Subject: AP1000 Response to Requests for Additional Information (SRP15.3)

Response to Requests for Additional Information on SRP Section 15.3

# AP1000 TECHNICAL REPORT REVIEW

RAI Response Number: RAI-SRP15.3-RSAC-01  
Revision: 0

**Table 1**  
**Potential Leak Paths and Characteristics for AP1000**

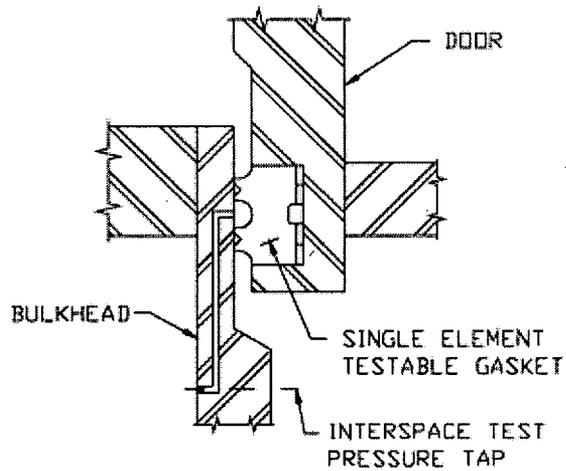
B) No geometrical information about the leak paths is provided other than a path height of 0.155 cm, crack size of 4.45 cm, and 1.75 inch crack depth. The staff believes that many of the hypothesized leak paths would be better approximated as orifices rather than passageways. The staff also finds that no sufficient geometrical information is provided to evaluate if leak paths are orifices, capillaries or straight channels. Treated as orifices, there would be no "walls" for the hypothesized inertial impaction of aerosols as you assumed. Please describe geometrical information about the leak paths in more detail with justification.

B) A description of potential containment leak pathways, their geometries and their discharge locations is provided on page 9 of APP-GW-GLN-122. The list of potential leak paths from that discussion is provided in Table 1. The most likely containment leakage occurs through multiple parallel pathways at penetrations and hatch seals (Figures 1 and 2 from DCD Chapter 3.8.2), which discharge to the auxiliary building and would be subjected to additional deposition before being released to the environment. Through-wall cracks in multi-pass butt welds in the containment shell are more unlikely and discharge to the passive containment cooling system (PCS) annulus.

To be conservative, Westinghouse models the leakage from the containment as a single round hole through the containment shell to the PCS annulus. The flow path is considered to be a smooth capillary, which is conservative as outlined below. The diameter of the hole, 1.55 mm, is determined by the design leak rate, which is the maximum diameter for postulated leak path. The length of the hole is determined by the straight-through thickness of the containment shell, which is 1.75 inches. The single hole modeled in AP1000 containment shell has a length to diameter ratio (L/D) that is, at a minimum, 28.6. According to Sutter (Reference 1) an orifice is an opening in which the length is smaller than or equal to the diameter of the opening. It is inappropriate to treat the hole in the AP1000 containment shell as an orifice.
